## D/DRC Case

S/S Blossom Street, 620 Blossom Street

**DESIGN/DEVELOPMENT REVIEW COMMISSION**  
**DESIGN REVIEW DISTRICT**  
January 9, 2014  
**EVALUATION SHEET**  
Case #6 Regular Agenda - Urban

**NATURE OF REQUEST:** Request for Certificate of Design Approval for new construction of private student dormitories.

PROJECT: **USC STUDENT HOUSING BLOSSOM STREET**  
 EDWARDS COMMUNITIES DEVELOPMENT COMPANY  
 RICHLAND COUNTY, COLUMBIA, S.C.  
**DDRC SITE PLAN**

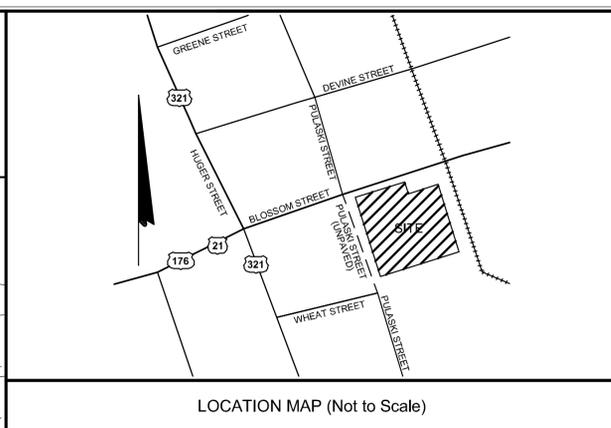
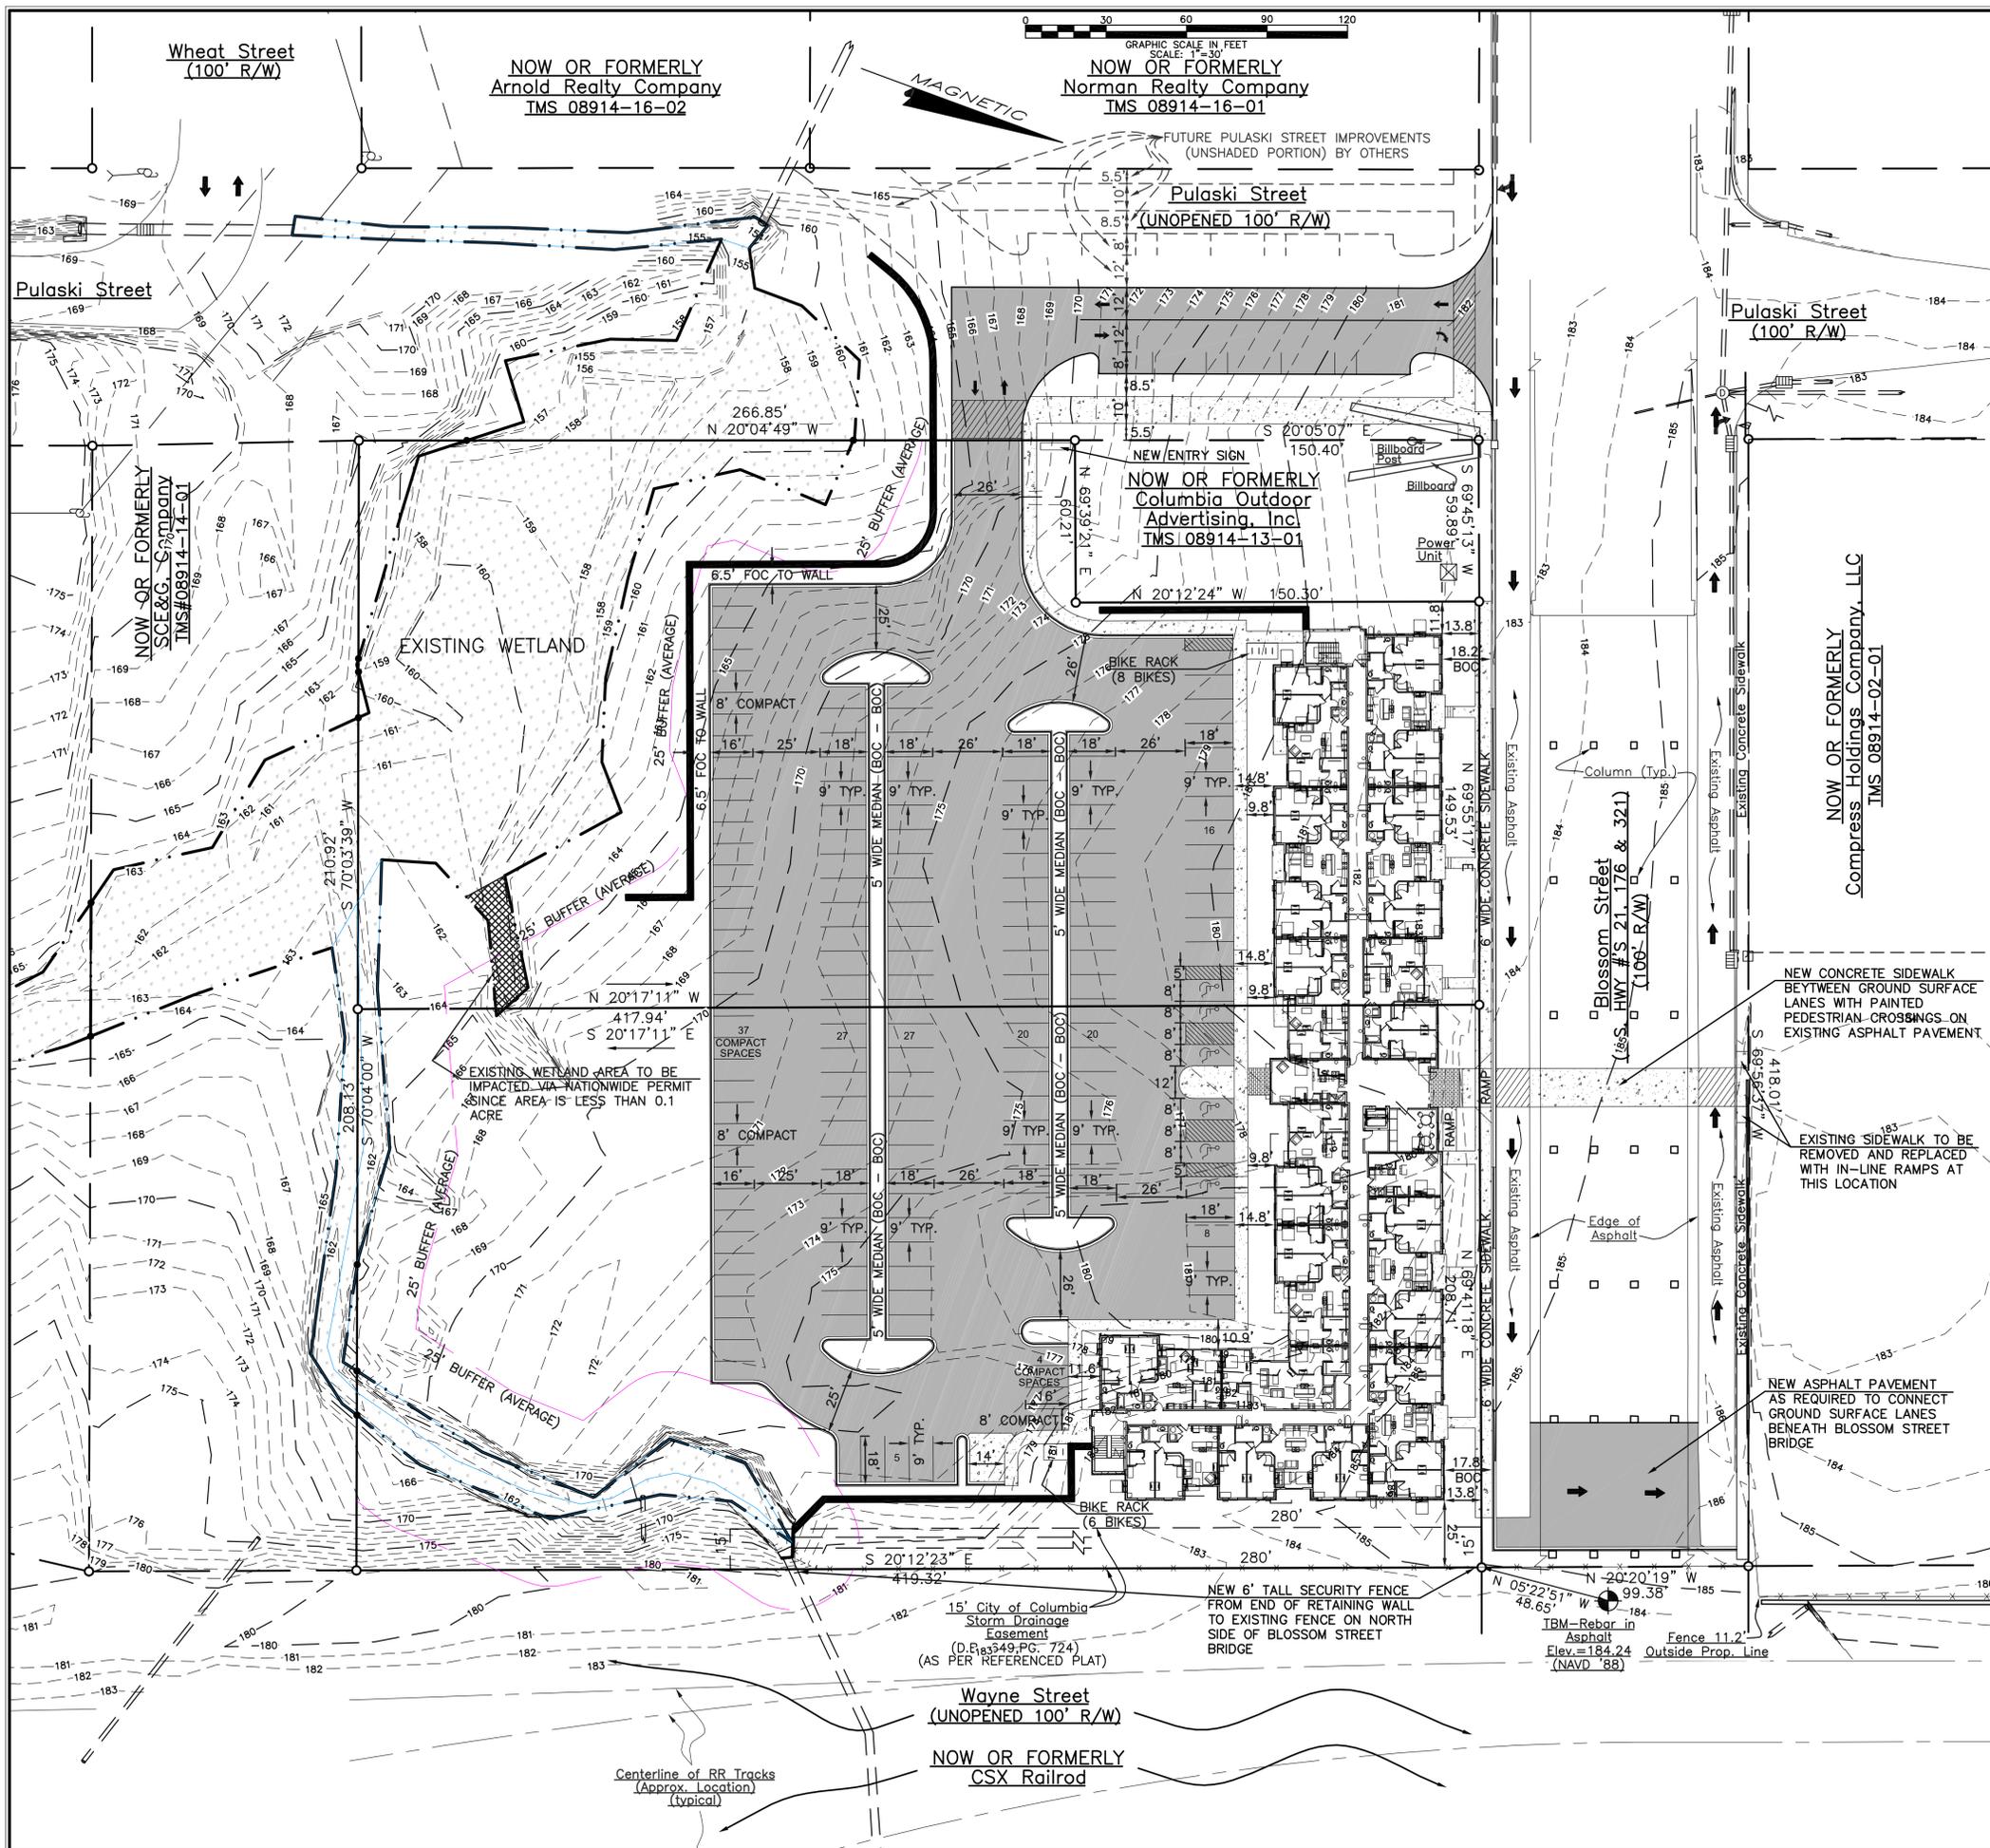
At the time of permitting, a more detailed and specific landscaping plan will need to be provided for compliance with the guidelines and code requirements.

1. Details of the hedges will need to be provided, details to be deferred to staff.
2. Street trees shall be installed at a minimum size of 2 ½ inch caliper and should be 14-16 ft high, details to be deferred to staff.
3. Internal landscaping shall meet the requirements of the landscaping ordinance.
4. An irrigation plan showing generally how irrigation will be provided internally to all landscaped areas shall be provided, details to be deferred to staff.
5. An irrigation plan for all landscaping within the right-of-way will need to be provided, details to be deferred to staff.
6. Details of masonry walls and retaining walls will need to be provided, details to be deferred to staff.

The applicant has provided a lot frontage that is either compliant or substantially compliant with section 1.5.6. Based upon staff calculations the structure along Blossom Street has 89% of its frontage at the 15 foot setback line.

**PROJECT:**  
**USC STUDENT HOUSING**  
**BLOSSOM STREET**  
 EDWARDS COMMUNITIES DEVELOPMENT COMPANY  
 RICHLAND COUNTY, COLUMBIA, S.C.  
**DDRC SCHEMATIC GRADING PLAN**

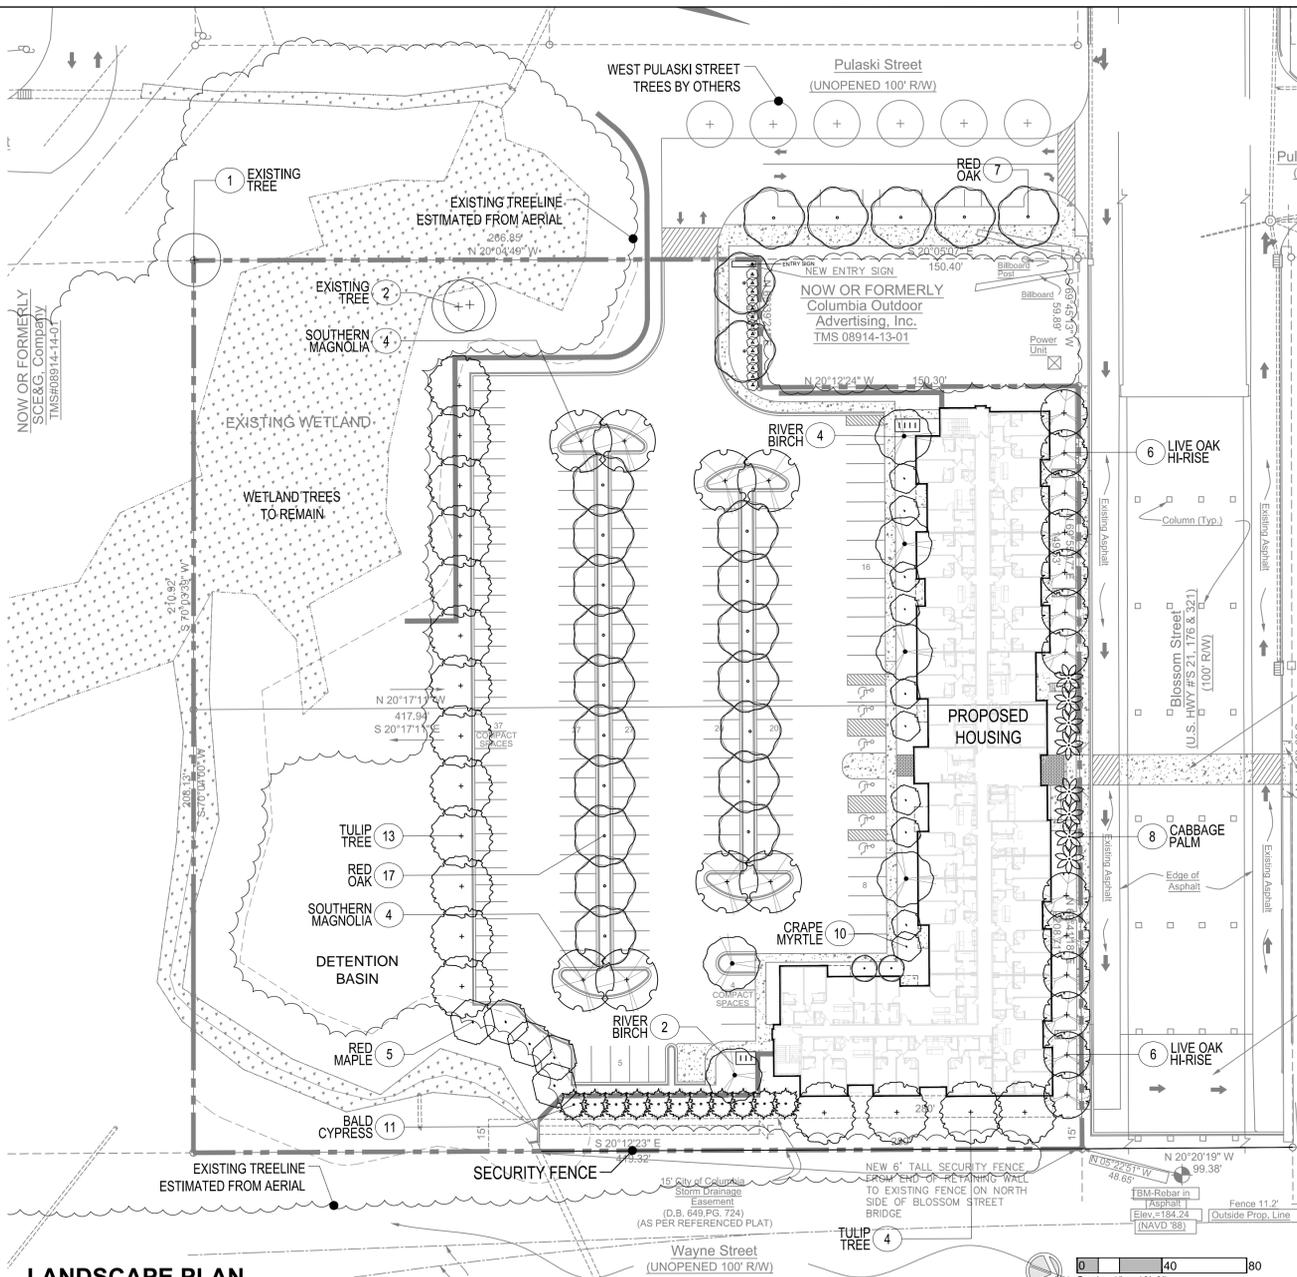
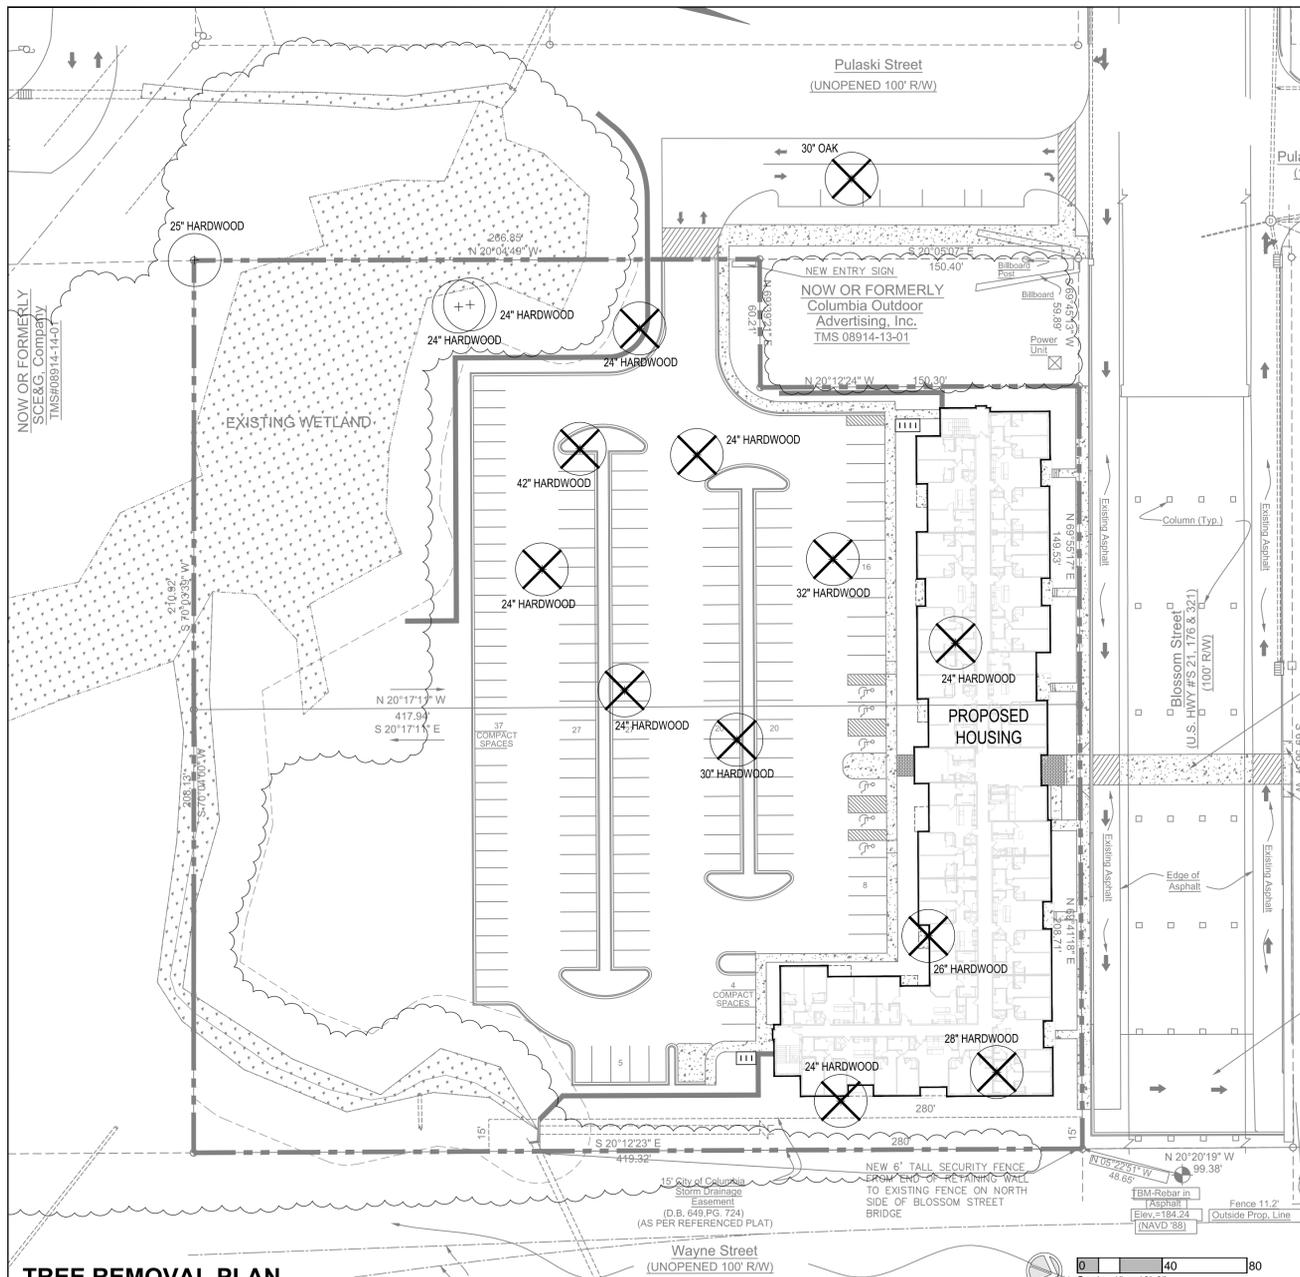
The applicant has proposed a building with minimal slope in the east west direction. Significant grading of the site will occur. Variations between the building foundation elevation and the changing elevation of the sidewalk and street will occur within the 15 foot front yard of the stature and will vary by a few feet.

Staff recommends that as the construction drawings are created and developed that attention will need to be provided for elevations with grade changes. Staff recommends that final review of the grading be deferred to staff.
